NUMBER: 23-046-22

Sky One Power Top Rattle

This bulletin involves checking the torque values on the Sky One-Touch power top screws and replacing all 16 screws if one is found with an incorrect torque value.

2020 - 2023 (JL) Jeep Wrangler

Fig. 1

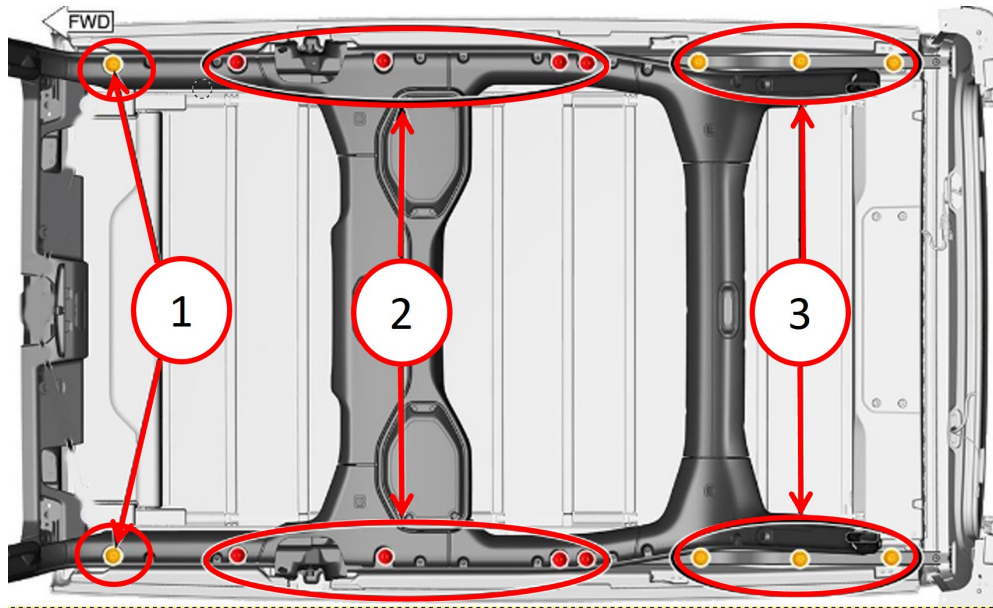
1. The power top system is fastened to the sport bar with 16 screws (Fig. 1) . **Verify torque for the 16 screws is correct. If any screw torque is not within specification, replace all 16 screws.**

NOTE: Use P/N 06513816AA for Rear Aperture and Front screws (Yellow Locations (Fig. 1)) and P/N 06513815AA for Body screws (Red Locations (Fig. 1)).

- 5 N·m (44 in. lbs.) - Power top assy to body screws.
- 6 N·m (53 in. lbs.) - Power top assy to body screws at B-pillar.
- 6 N·m (53 in. lbs.) - Power top assy to body screws at rear aperture.

- 1 - Front Screws 70 mm (2.75 in.) Screw Length (Yellow Locations)
- 2 - Middle Screws 103 mm (4 in.) Screw Length (Red Locations)
- 3 - Rear Door Opening Screws 70 mm (2.75 in.) Screw Length (Yellow Locations)
